**NARRAGANSETT BAY COMMISSION
ONE SERVICE ROAD PROVIDENCE, RI 02905**

**CSO PHASE IIIA
OF-217 Consolidation Conduit
CONTRACT 308.05C**

**ADDENDUM NO. 1
August 19, 2021**

SHEET C-3
195130227

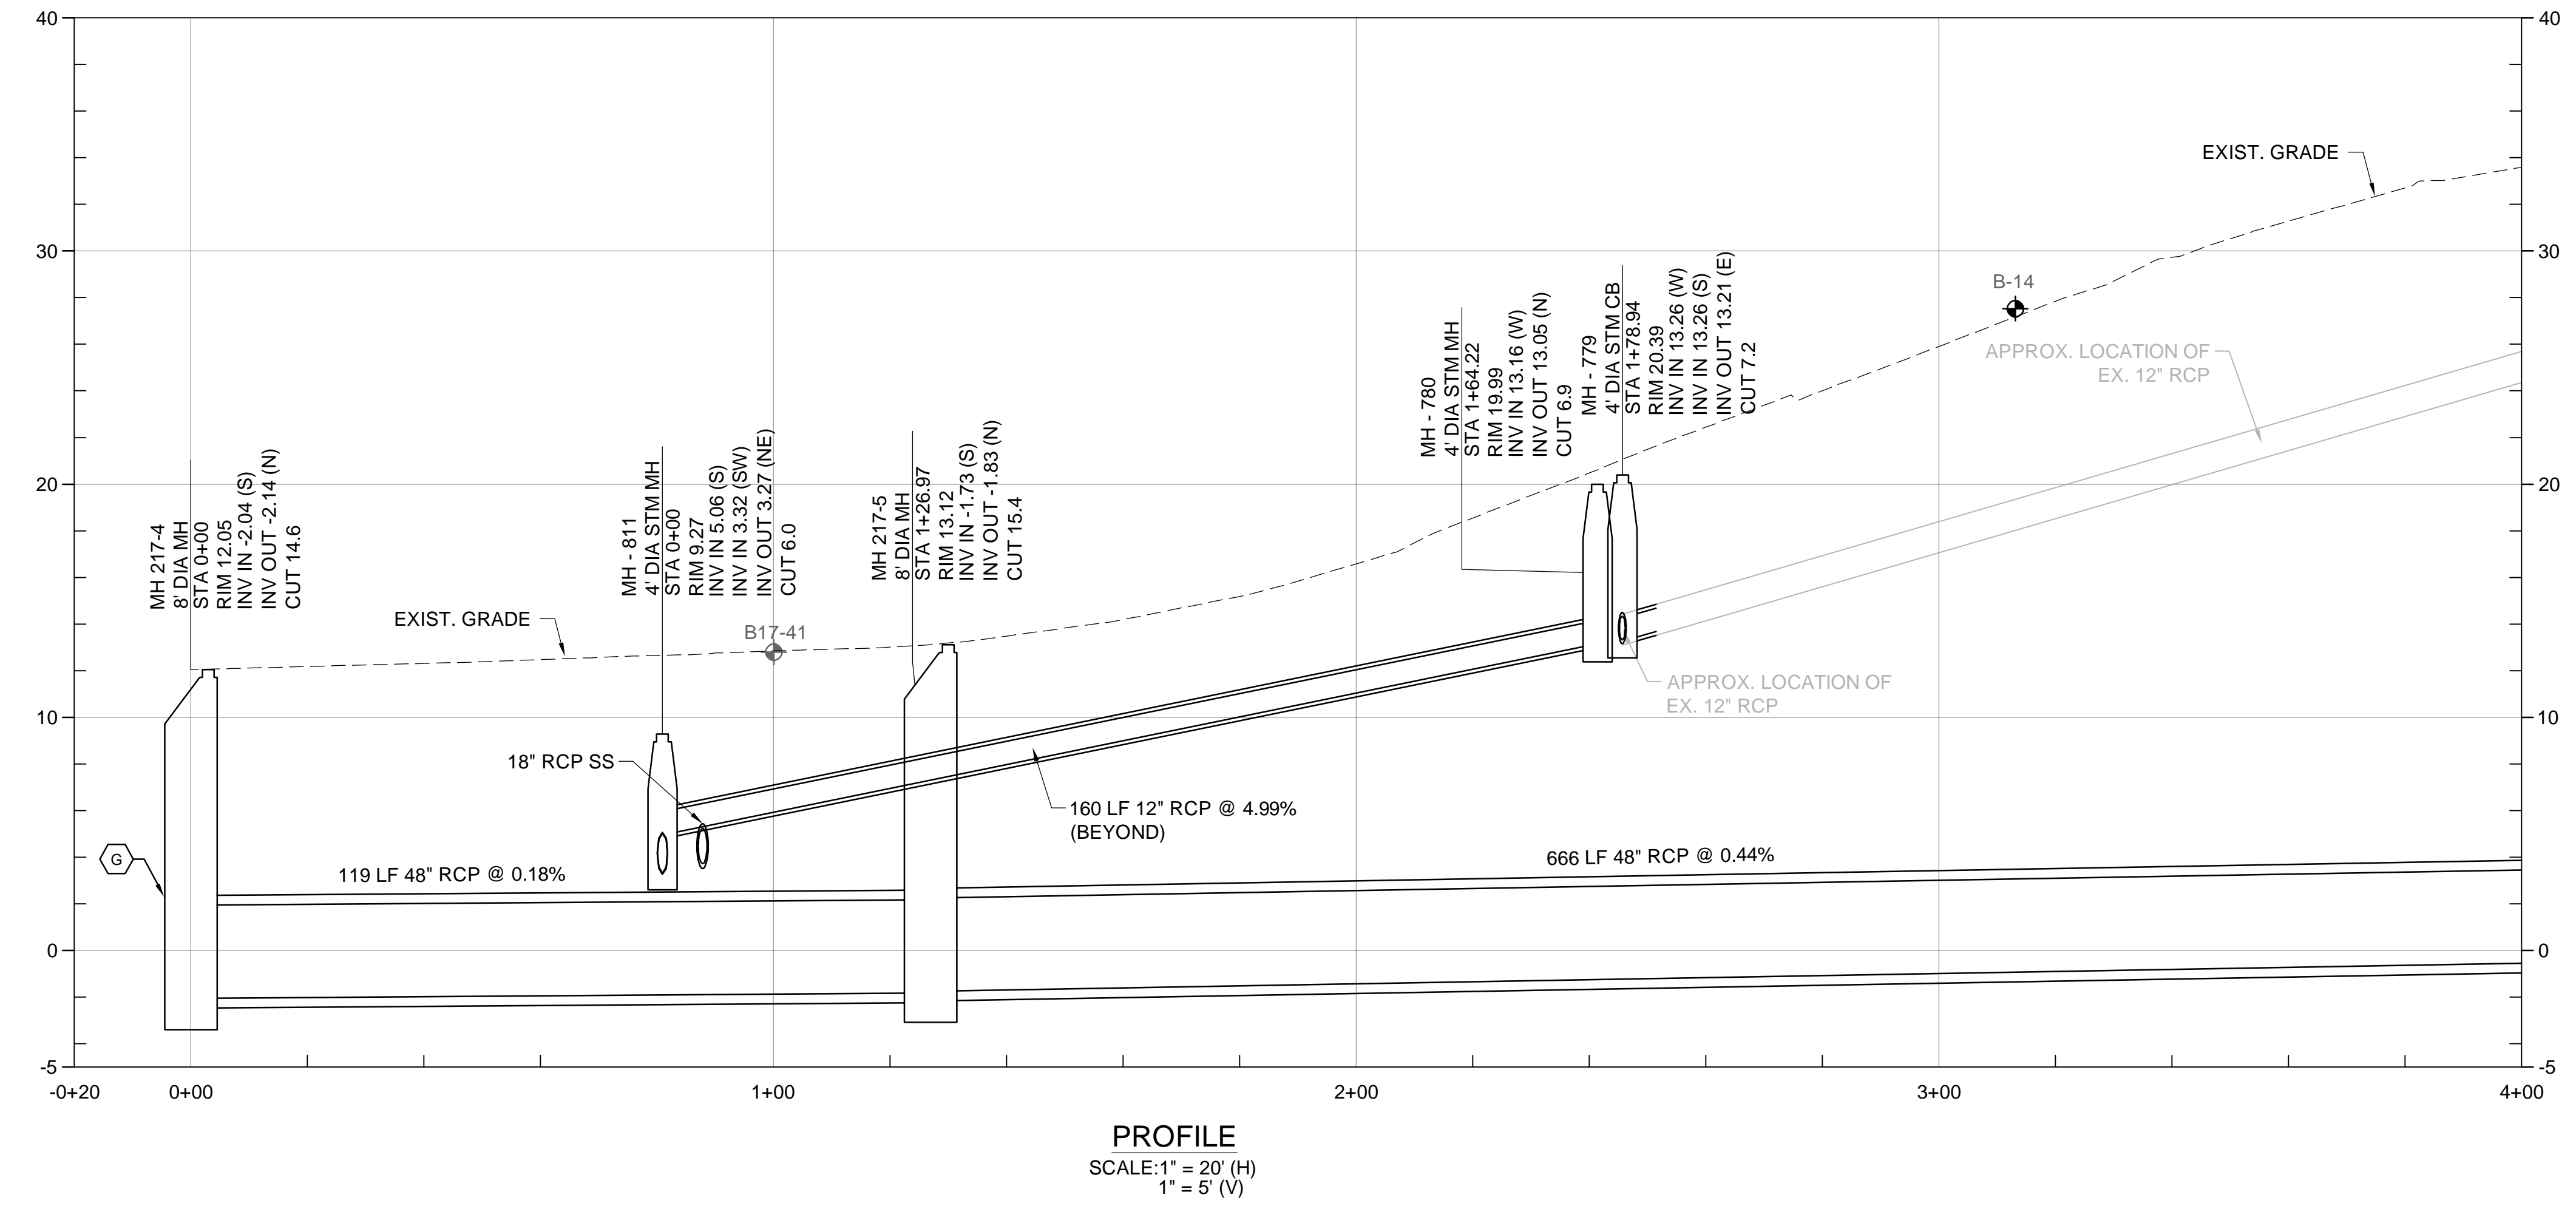
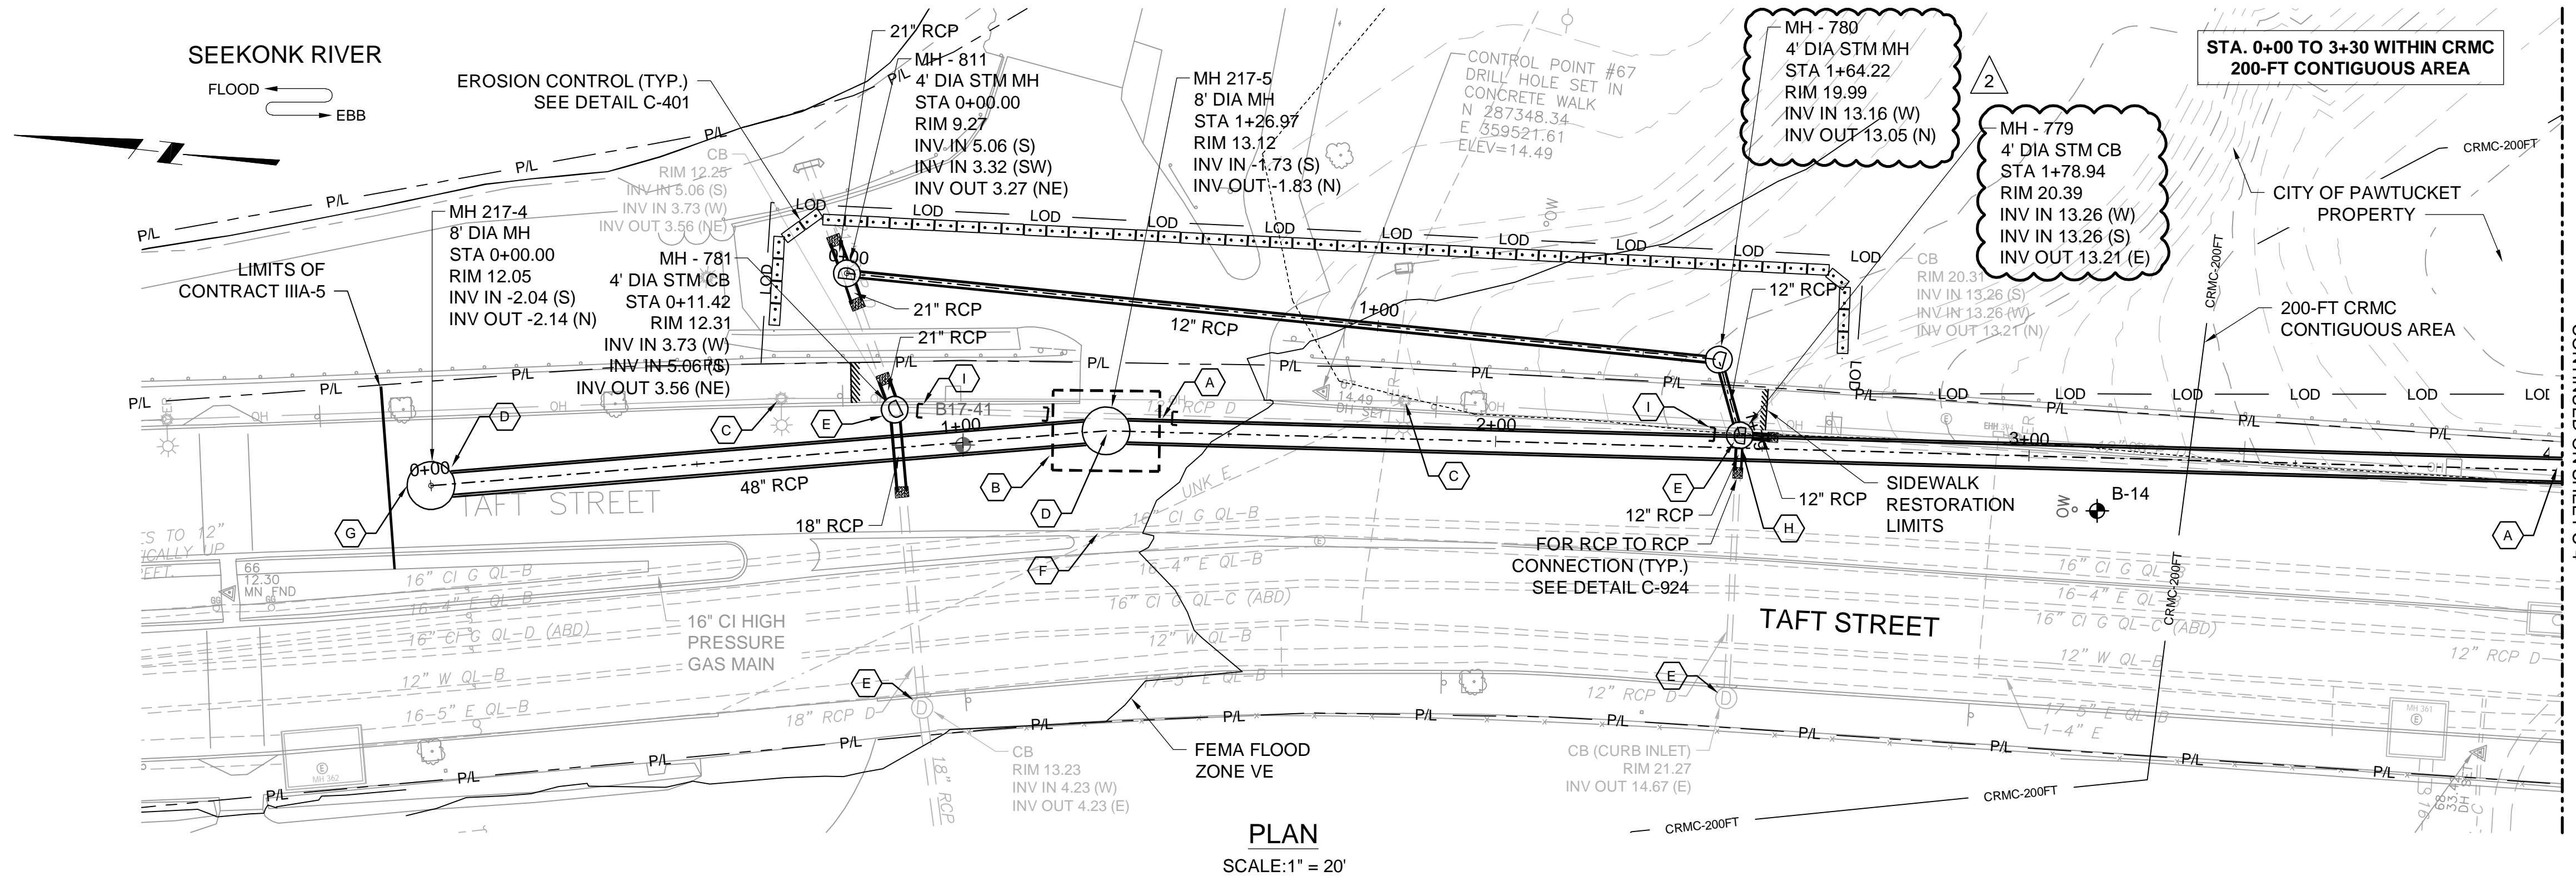
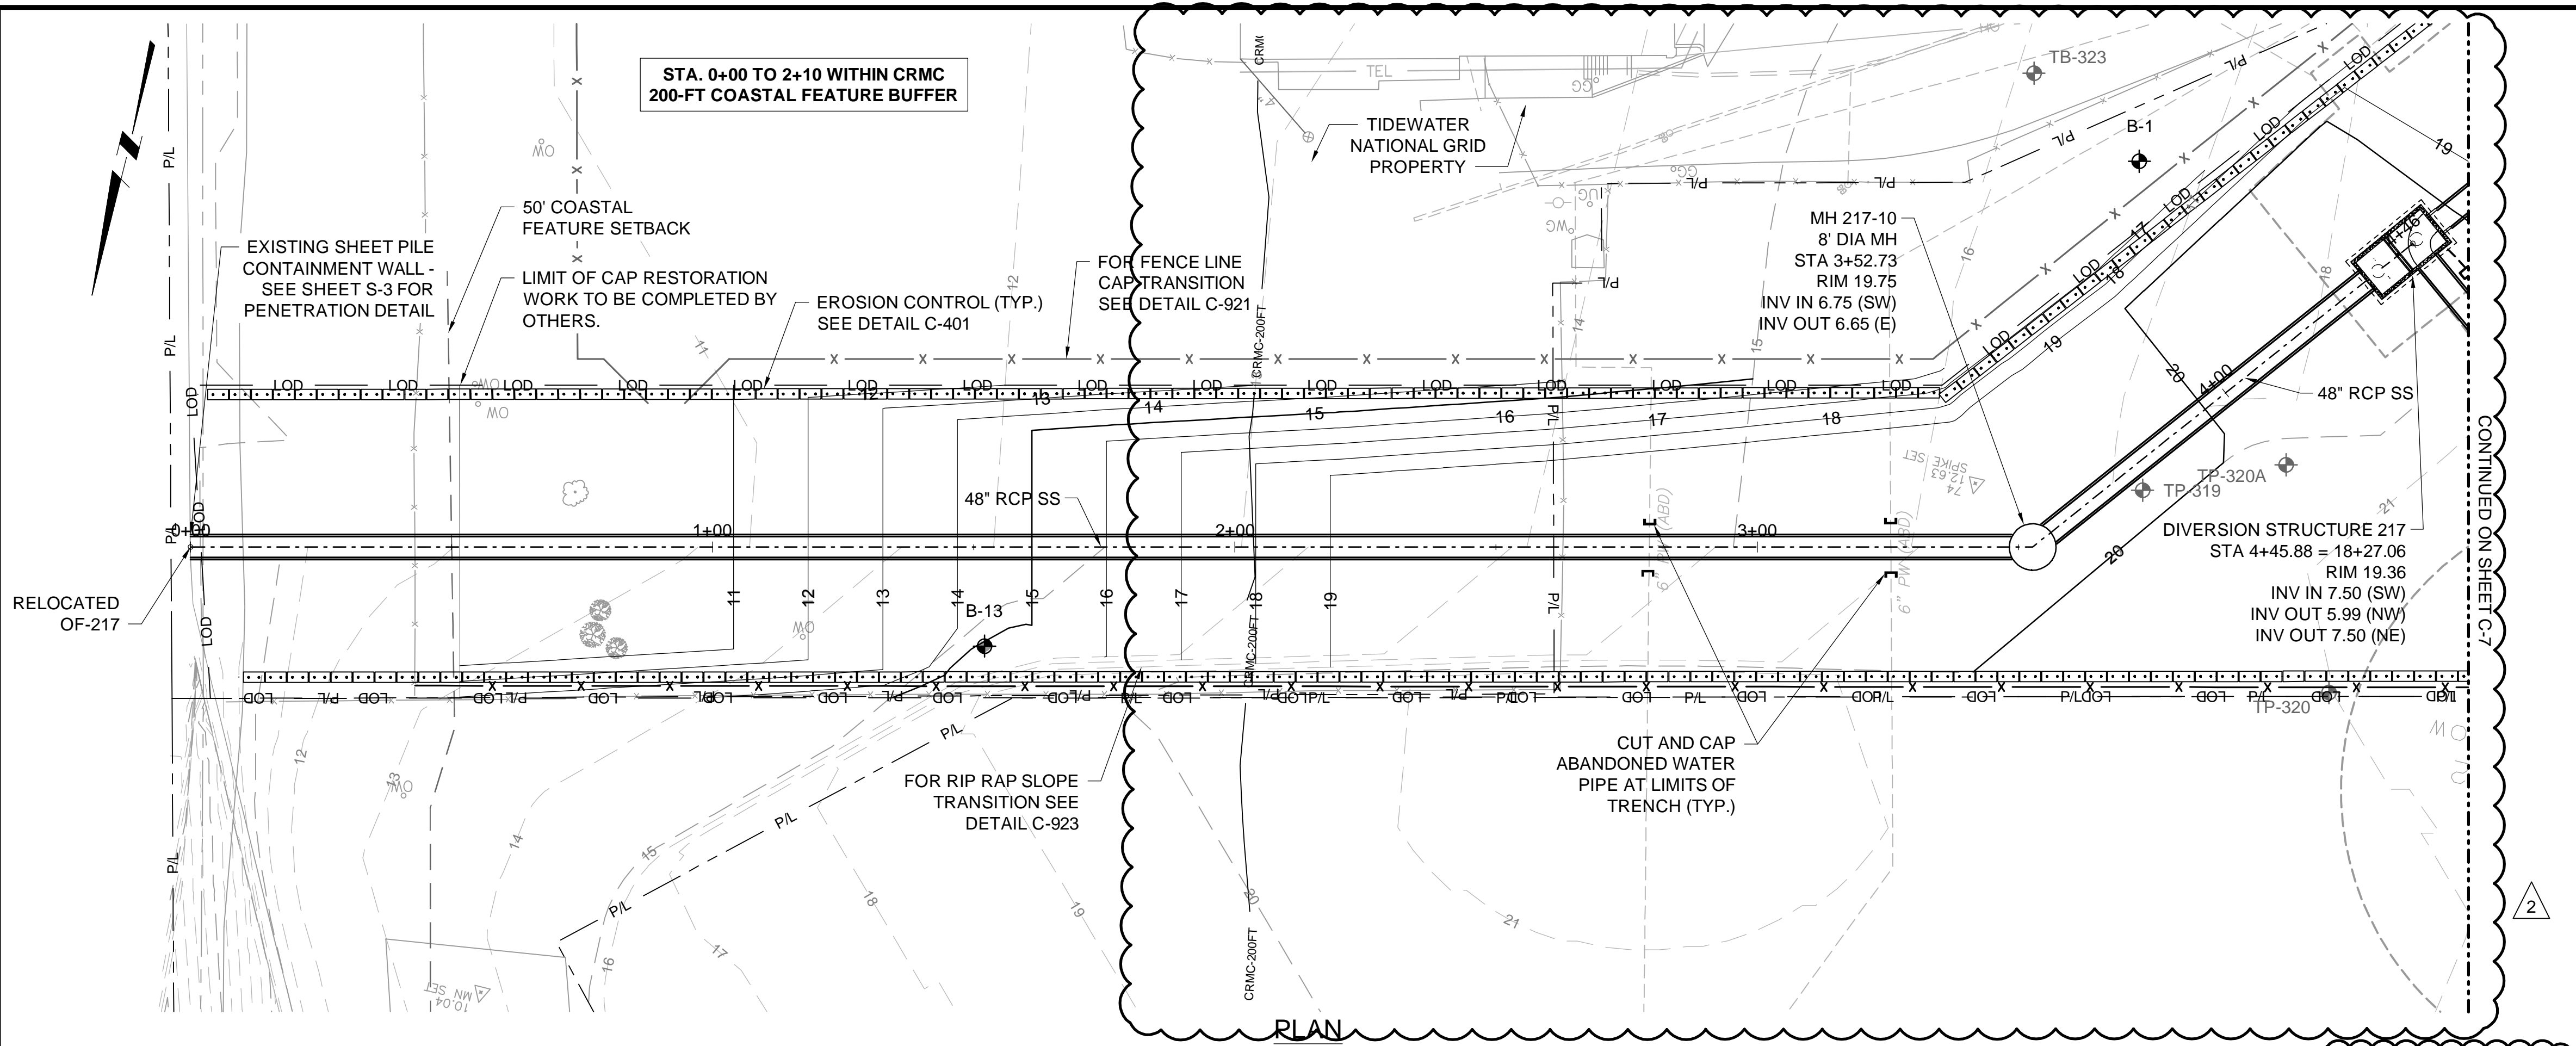
Item 1-8: Drawing C-3 shall be **DELETED** and **REPLACED** with Drawing C-3 attached hereto (see Addendum No. 1, Attachment 6).

1. Sheet C-3 indicates the limit of sidewalk restoration but does not indicate any pavement restoration for any open cut pipe installation in the roadway. Is the intent to only patch the trench in accordance with details C-911 and C-912?

Response: Correct. Temporary and permanent trench paving is required in accordance with C-911 and C-912 for sections of pipe within paved surfaces that are installed utilizing open cut construction techniques.
